ECN/PCN No.: M1230

For Manufacturer			
Product Description: RJ45, 2x2 Multi Port, 100/1000/2.5G/5G Base-T Magnetics Module	Abracon Part Number / Part Series: ARJM22 series	<input type="checkbox"/> Documentation only <input checked="" type="checkbox"/> ECN <input type="checkbox"/> EOL	<input type="checkbox"/> Series <input checked="" type="checkbox"/> Part Number(s)
Affected Revision: <p style="text-align: center;">A</p>	New Revision: <p style="text-align: center;">B</p>	Application:	<input type="checkbox"/> Safety <input checked="" type="checkbox"/> Non-Safety

Part Number Identification

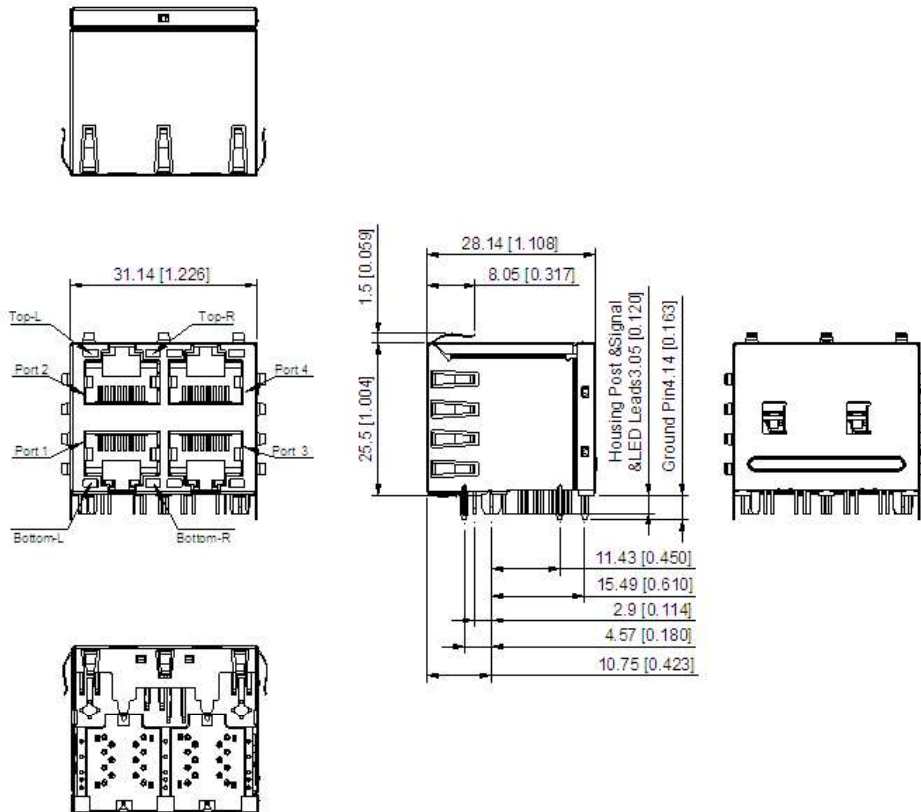
Prior to Change:

ARJM22 - - - -

ARJM22

EMI Finger	Schematics	Left LED color	Right LED color	Operating Temperature	Gold Plating
A1: w/ EMI Finger	A12: 100 Base-T 547: 1000 Base-T 805: 2.5G Base-T 811: 5G Base-T	N: No LED A: Green B: Yellow	N: No LED A: Green B: Yellow	CW: 0 ~ 70 °C EW: -40 ~ 85 °C	2: 6u"

Mechanical Dimensions
A1: 2 x 2, w/ EMI Fingers

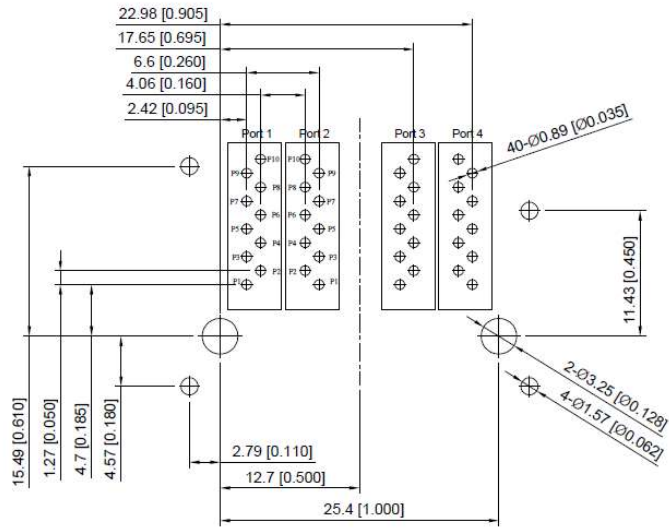
1000Base-T w/o LEDs

Part Number Identification

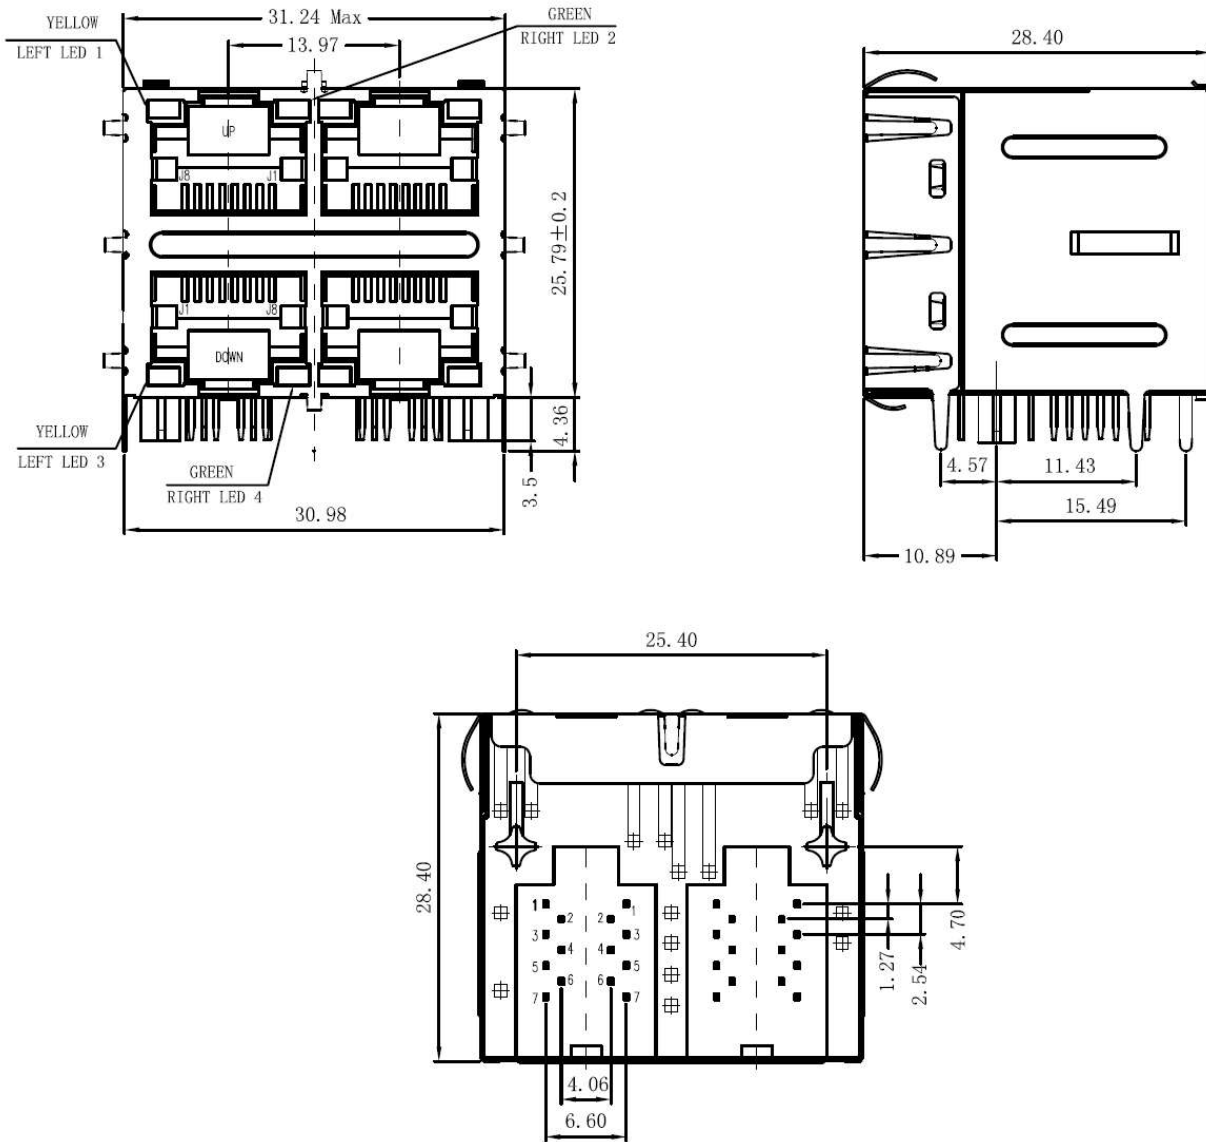
After Change:
Electrical Specifications

ARJM22 [] - [] - [] [] - [] []

Mechanical Specifications

A1: 2 x 2, w/ EMI Fingers

Cause/Reason for Change:

Moving to new production line.
